Streamlined Remediation System Evaluation
Wash King Laundry Superfund Site
Pleasant Plains Township, Michigan

STREAMLINED REMEDIATION SYSTEM EVALUATION

Report of the Streamlined Remediation System Evaluation
Conference Call Conducted for the Wash King Laundry Site
July 26, 2010

Revised Report
February 18, 2011

06-712-01	FEBRUARY 2010	FIGURE 15 B
-----------	---------------	-------------

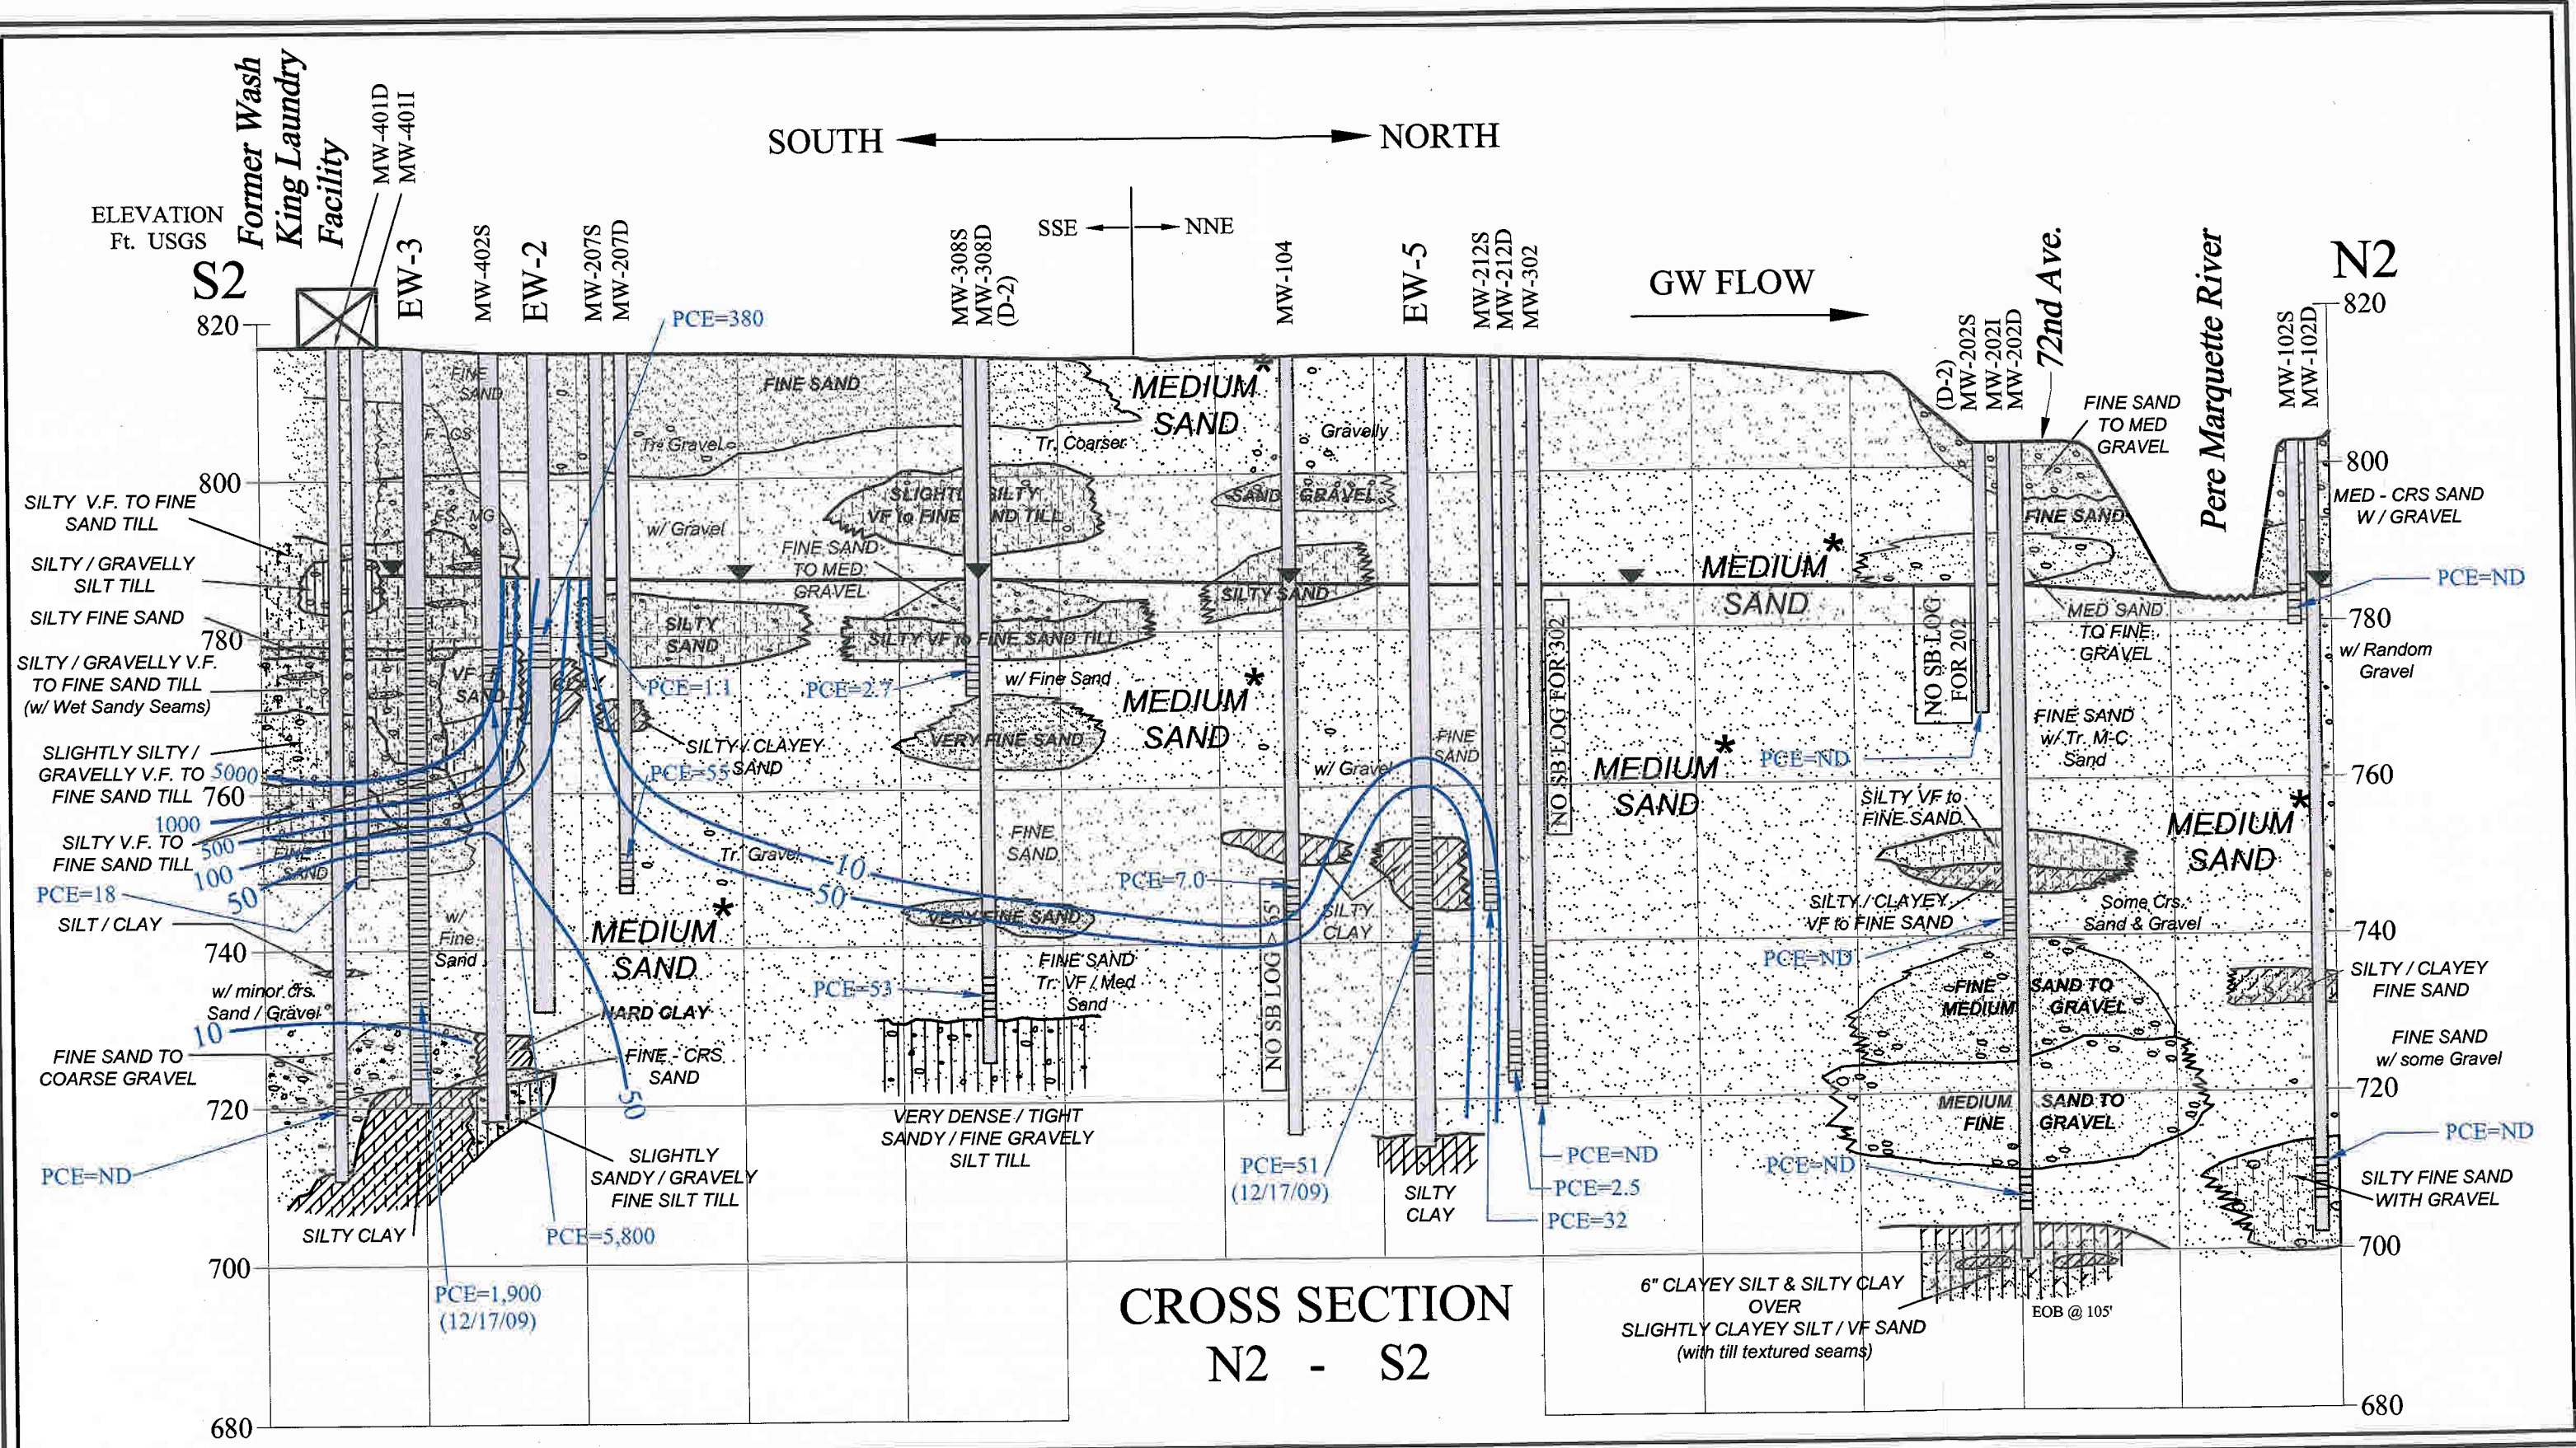
The vertical distribution of contamination is also presented in the north-south cross-sections presented in Figures 15B, 16B, and 17B.

FIGURE 13

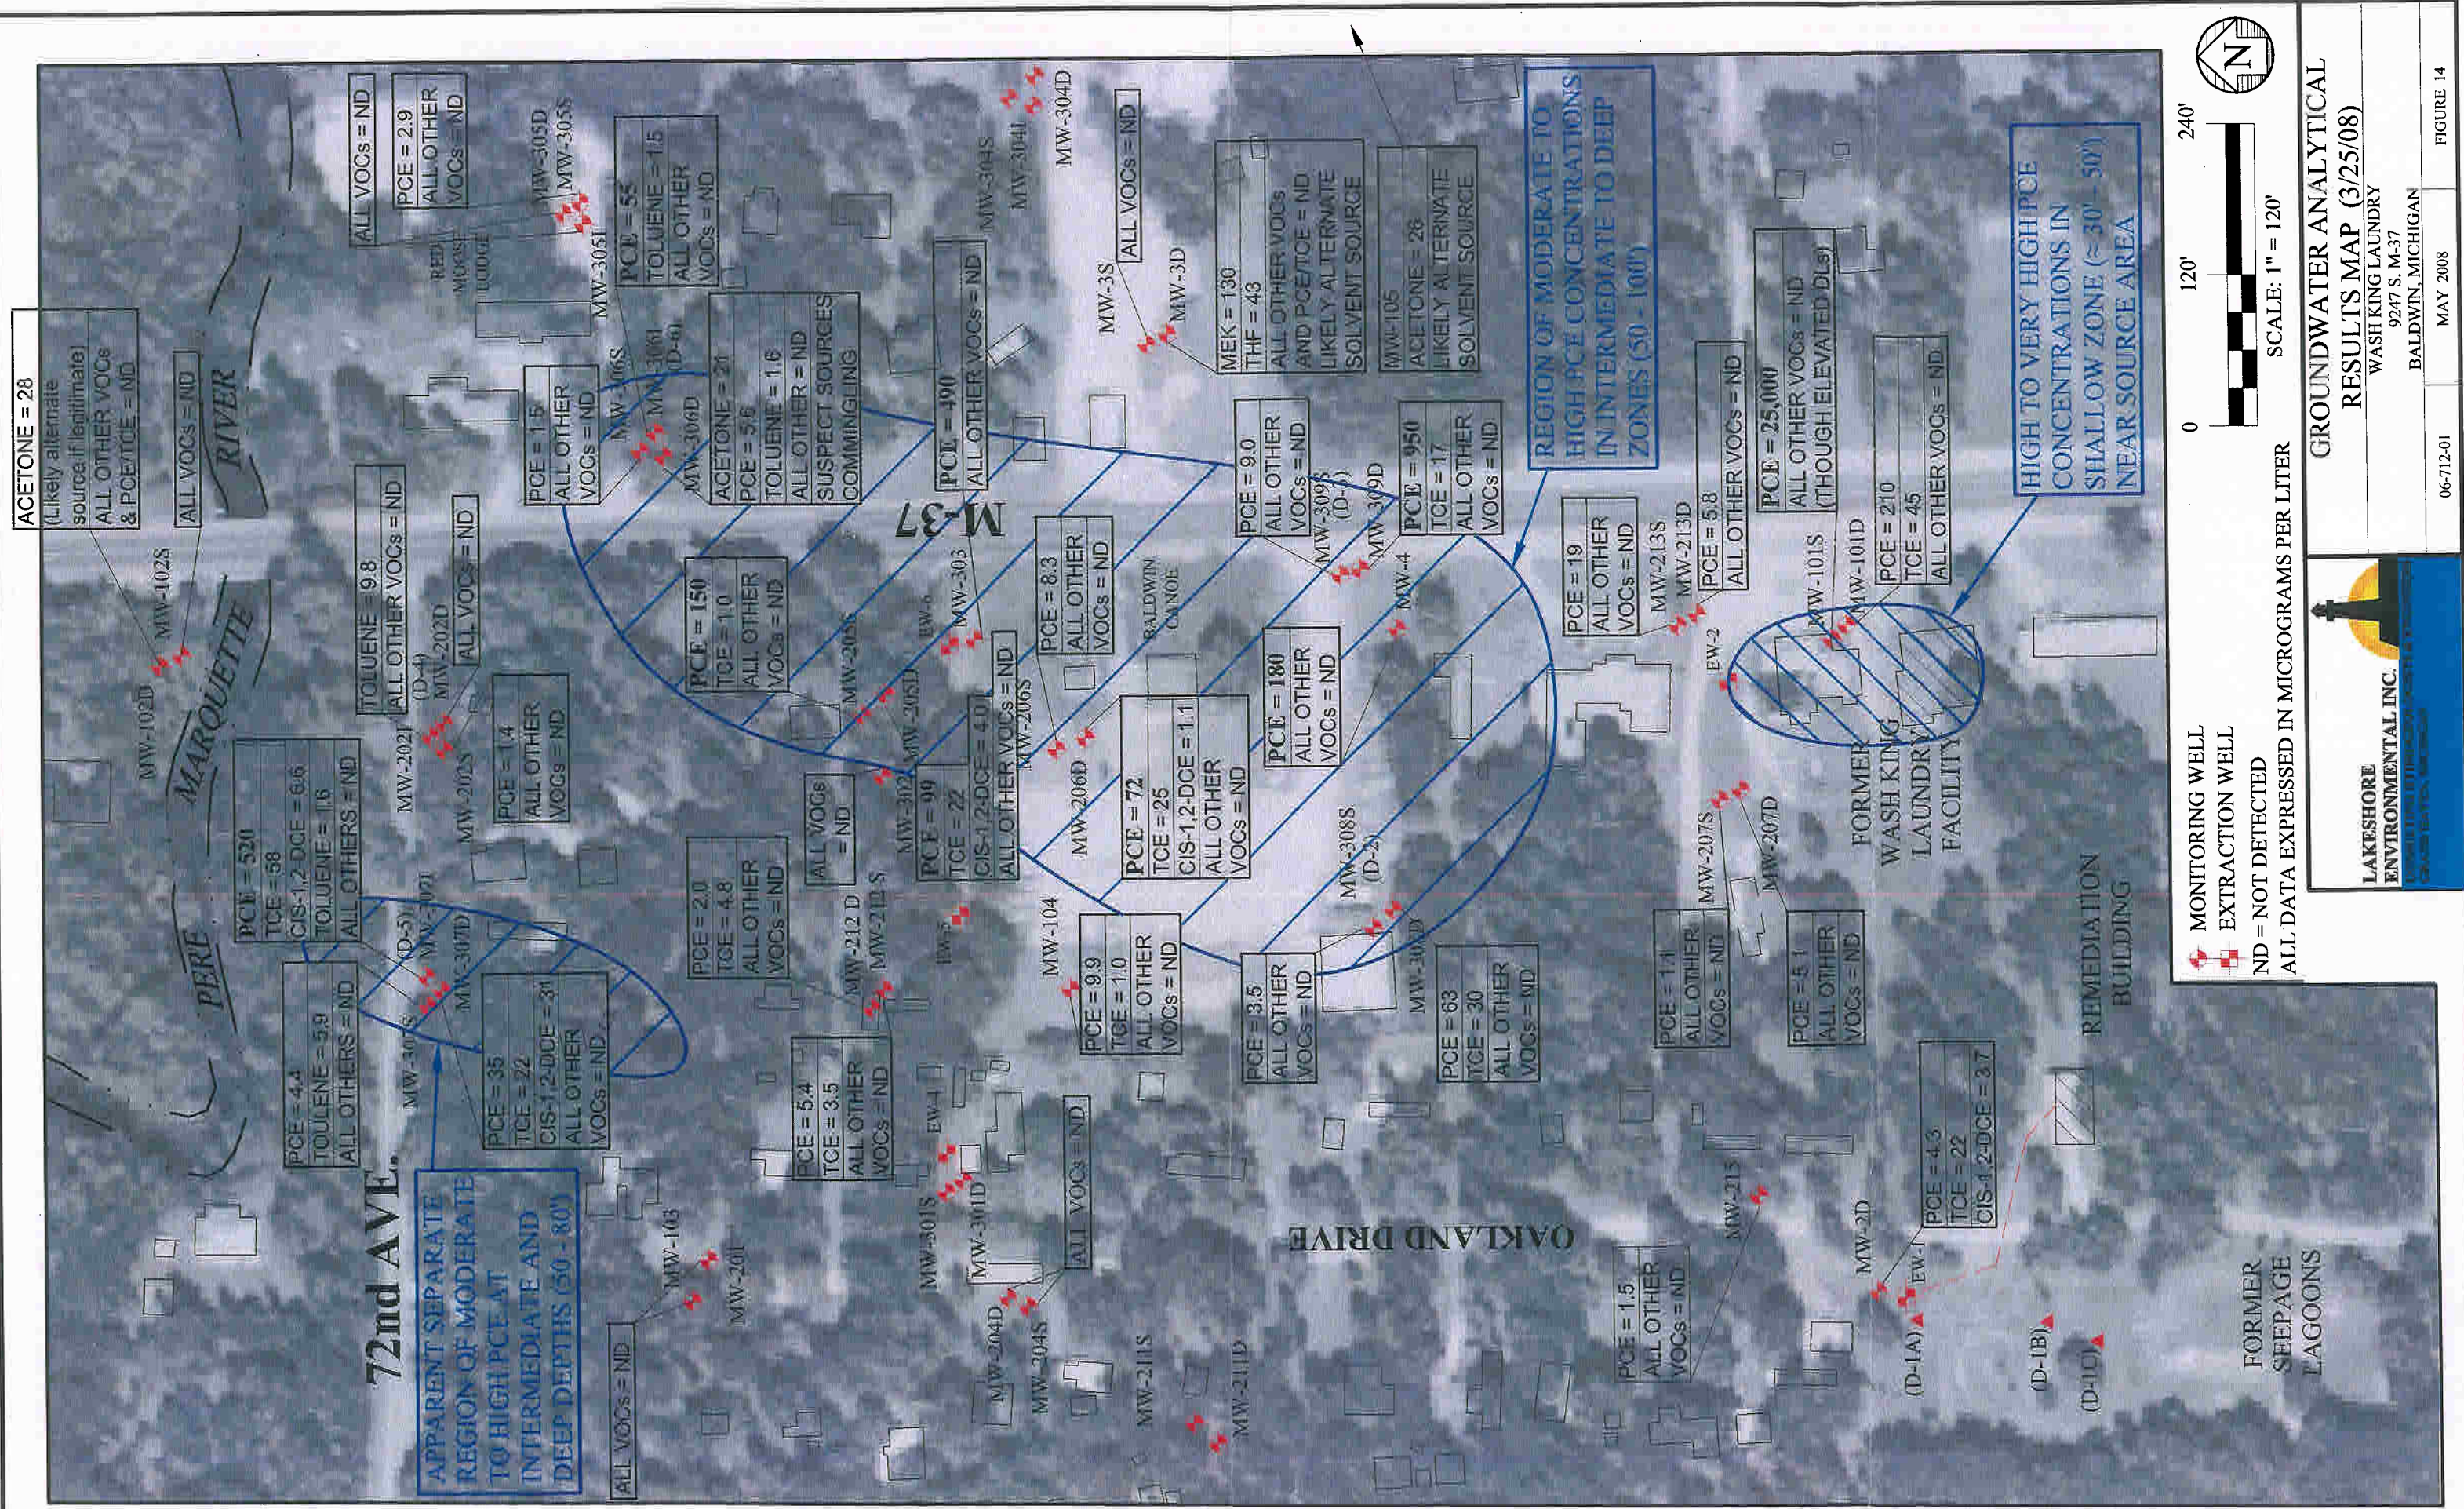
Groundwater flow under non-pumping and pumping conditions in 2008 (prior to the installation of EW-7) are presented in Figures 11 and 13 (see Attachment A). Figure 11 illustrates that groundwater flows to the north, north-east toward the river, and the slight curvature of the contours in the vicinity of EW-6 may result from incomplete aquifer recovery prior to collecting the non-pumping round of water levels. Figure 13 provides the site team's depiction of the horizontal capture zone. The RSE-lite team evaluated the water levels and potentiometric surface map and generally agrees with the interpreted potentiometric surface map and extent of the capture zone in the vicinity of EW-4, EW-5, and EW-6. In general, when evaluating capture in the area of these wells, the intermediate and deep wells should generally be used because that is the interval where most of the contamination is present. There are a few instances where water levels from individual wells do not appear accurate based on water level measurements from surrounding wells or other wells in the well cluster. MW-202D and MW-206D are a few examples. The inconsistencies appear to occur during each water level event, suggesting that a survey error may be the cause.

The capture zones in the vicinities of EW-1 and EW-2 is based on limited data. The extent of capture from EW-2 may be overestimated in Figure 13. Use of water level data from the new 400 series monitoring wells will provide more information to interpret capture and extraction from EW-7, which is now occurring, will greatly improve capture in this area. Based on the observed drawdown and the background water hydraulic gradient, the interpreted capture zone near EW-1 is likely a reasonable approximation.

FIGURE 26 c

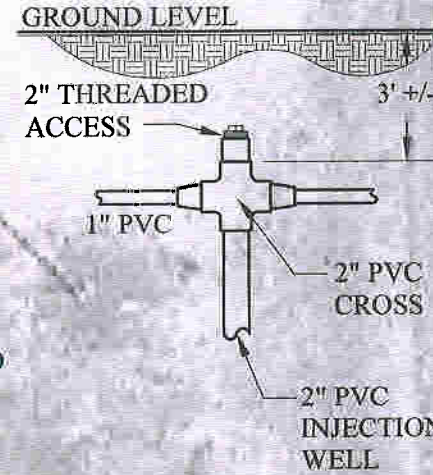
The as-built schematics for the bioremediation system are show in Figures 26C, 27, and 28 (see Attachment A). The RSE-lite team has little additional information on system operation and performance and therefore cannot comment on system performance or effectiveness.
